XV TRANSVERTER OWNER'S MANUAL ERRATA

Rev. F1-1, January 26, 2016

E740096E

**MAKE THE FOLLOWING CHANGES TO YOUR REV F1
MANUAL**

XV50 R.F. Circuits Schematic
(R.F. Board)

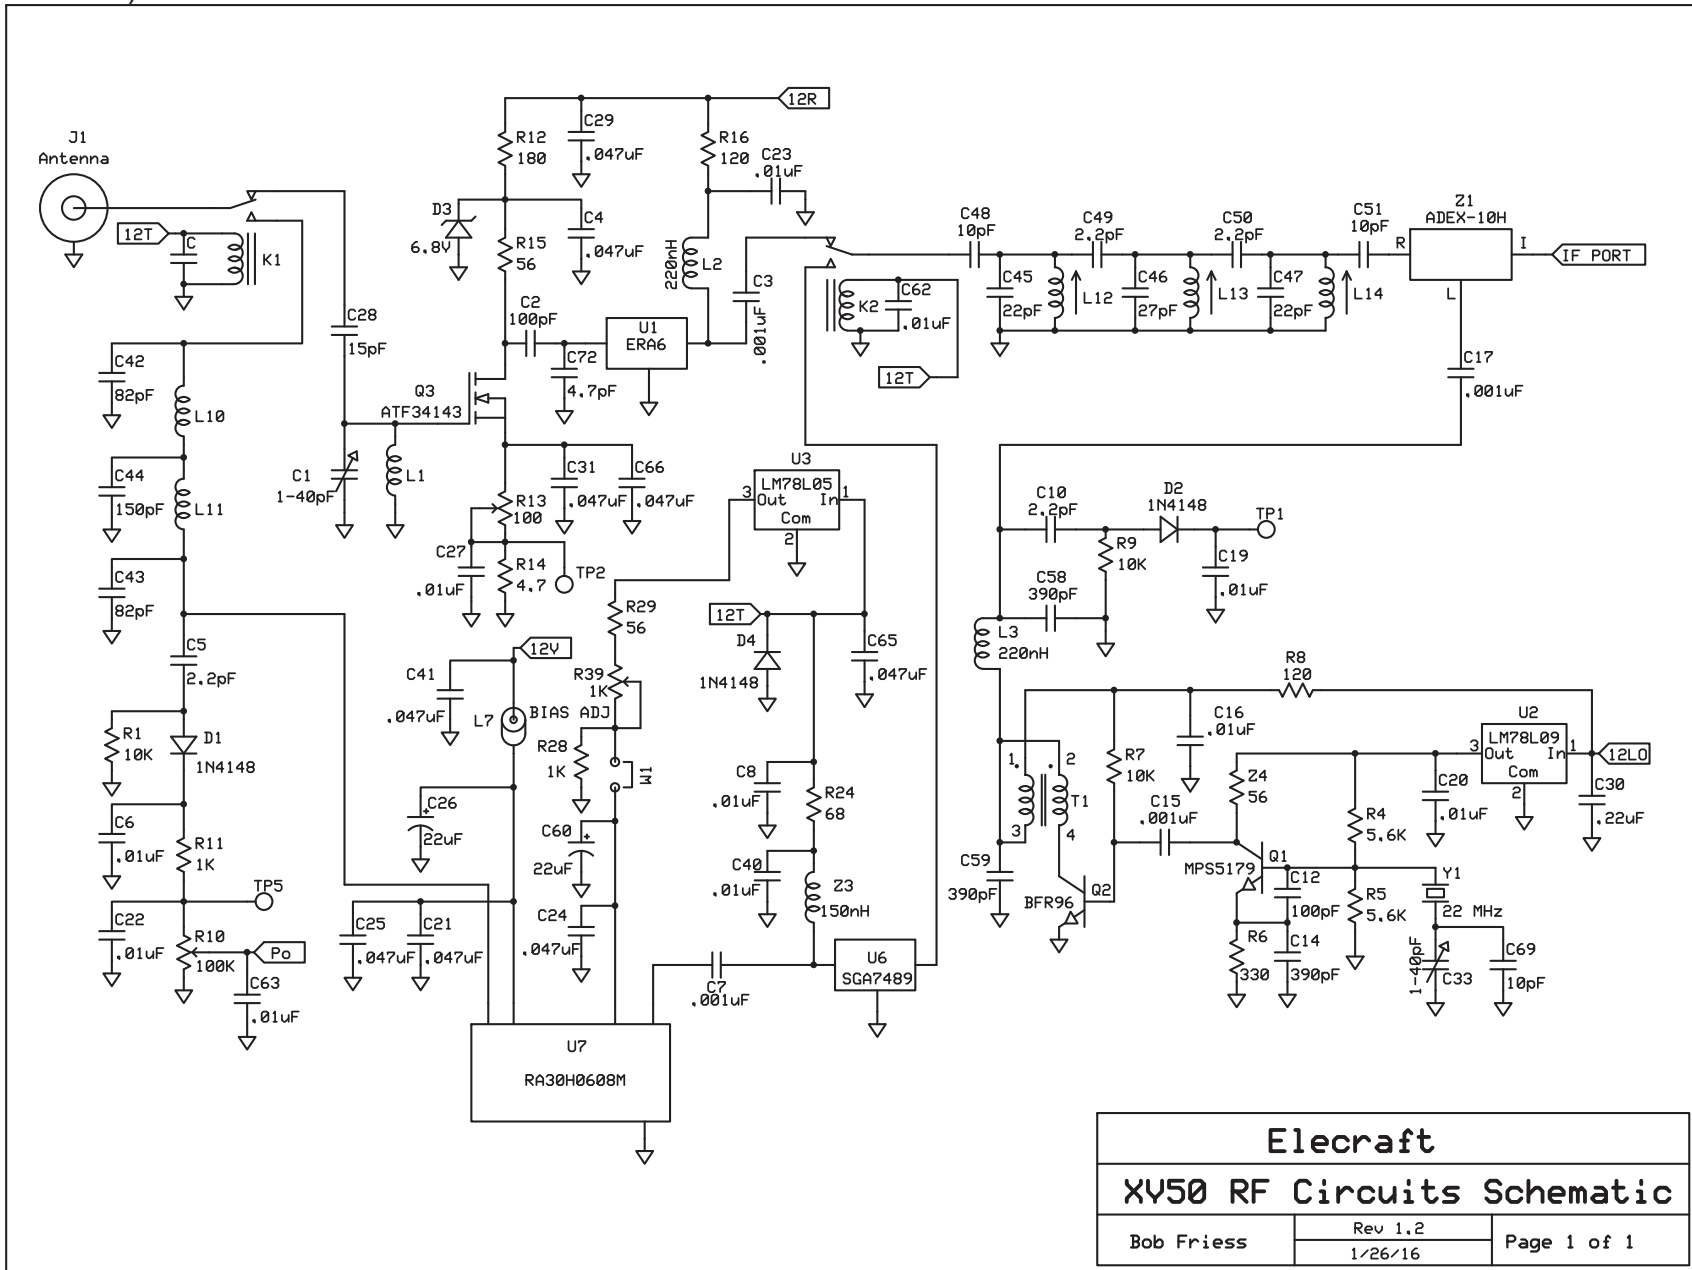
1. **Appendix A, Page A-6:** Replace the page with page 2 of this errata. The updated schematic includes Resistor R7 that was missing from the earlier version.
